N-series Intel[®] Pentium[®] Processors and Intel[®] Celeron[®] Processors

Specification Update

December 2019

Revision 018

GPIO Family RCOMP Register

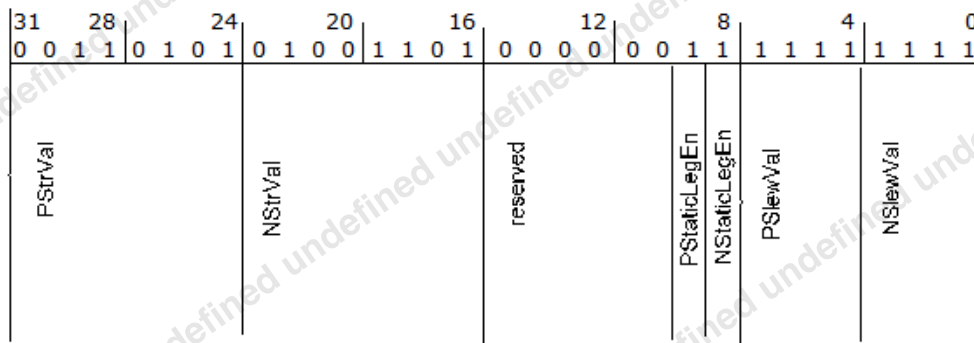
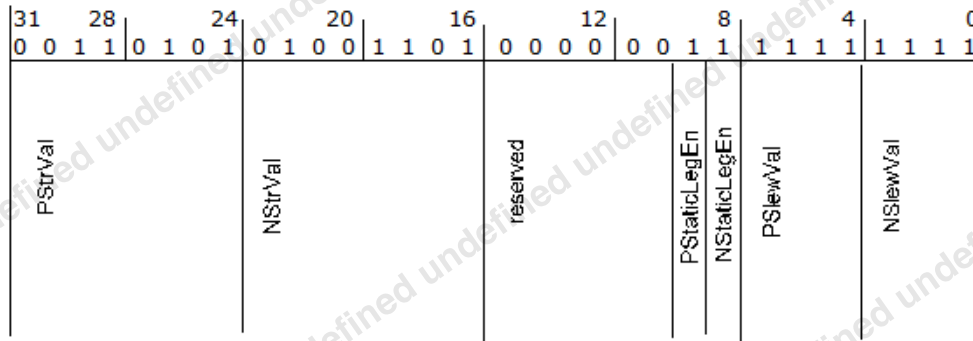
This section provides additional notes to describe the bit range of PSlewVal and NSlewVal in section 33.7.67 Family_config_rcomp_reg (hshvfamily_3x3_rcomp_9_0_family_rcomp_value_reg) - **Offset 1210h**

- Note:**
1. For LPC IO family, bits [5:4] are used to configure the PSlewVal, and bits [7:6] are reserved.
 2. For LPC IO family, bits [1:0] are used to configure the NSlewVal and bits [3:2] are reserved.

Bit range	Default and Access	Field Name (ID): Description
7:4 ¹	0xf RW	P Slew Value (PSlewVal): Slew values for Pull-up settings.
3:0 ²	0xf RW	N Slew Value (NSlewVal): Slew Values for Pull-down settings.
